UNITED STATES PATENT AND TRADEMARK OFFICE

APPLICATION NO.	FILING DATE	FIRST NAMED INVENTOR	ATTORNEY DOCKET NO.	CONFIRMATION NO.
10/768,939	01/30/2004	Thomas Robert Gold	672P001	7176

Office Action Summary

DETAILED ACTION

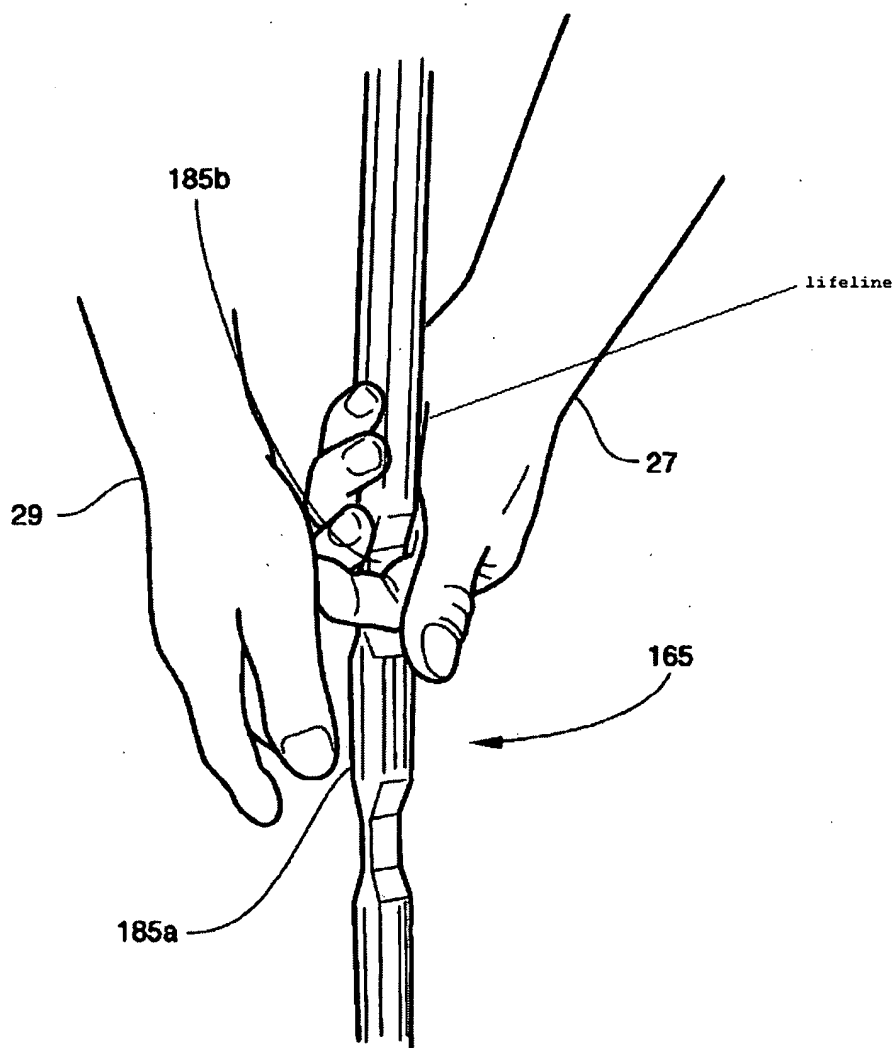
Regarding claims 1 and 13, the added limitation that the "shaft is not positioned between the target side arm and the player's rib cage" is inapt because it is inconsistent with applicant's originally filed drawings. See applicant's own Figure 4C below where the shaft is clearly positioned along the dashed line between the target arm side and the player's rib cage side.

Further, the claims also require that the shaft be positioned "against the player's armpit or area at the front of shoulder of the arm of the target side hand" (second sub-paragraph). As the armpit is the area beneath the shoulder and the shoulder is a part of the body between the rib cage and the arm, the armpit is necessarily between the arm and rib cage. Therefore, the shaft cannot be positioned against the armpit and meet applicant's added limitation.
